Service Information

Category U	Repair Guidance	Ref. No. R085/15A	Page 1 of 2
Coverage <input type="checkbox"/> Distributor only <input checked="" type="checkbox"/> Please inform your dealers		Date Issued September 16, 2015	
Please convey this information to your <input type="checkbox"/> Director <input checked="" type="checkbox"/> General Manager <input checked="" type="checkbox"/> Warranty Dept. <input checked="" type="checkbox"/> Parts Dept. <input checked="" type="checkbox"/> Training Dept. <input checked="" type="checkbox"/> Field Rep.		Date Revised November 20, 2015	
Applicable Model MX-5 (ND)		Applicable Countries or Specifications Worldwide

Subject: Poor A/C performance

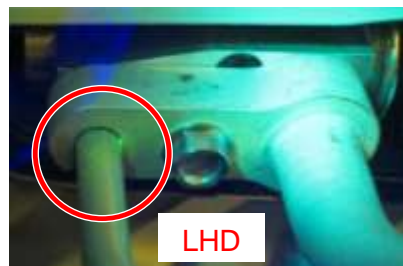
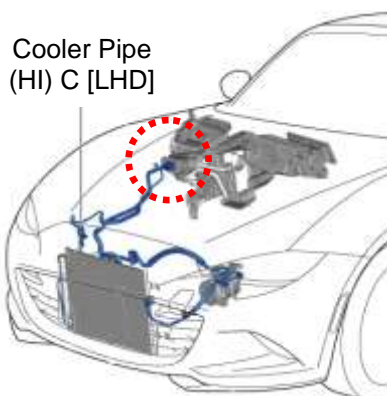
Due to the tolerance of the O-ring groove on the cooler pipe (high pressure side) at the expansion valve, it may cause slow leakage of the refrigerant.

Production process of the pipe has been changed.

Leakage at Expansion Valve

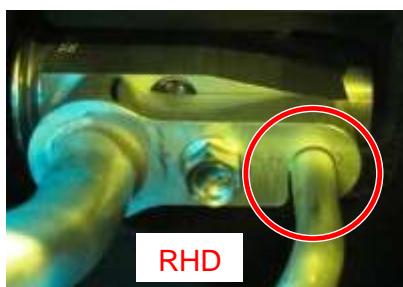
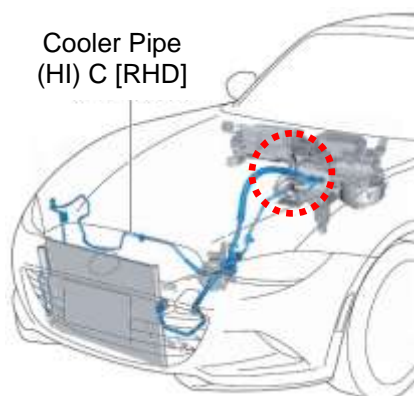
Using a refrigerant leak detector or a black light, determine the leakage. If it leaks at the connection where the "Cooler Pipe (HI) C" connects to the expansion valve, replace the "Cooler Pipe (HI) C" with a new one according to the Workshop Manual "REFRIGERANT LINE REMOVAL/INSTALLATION".
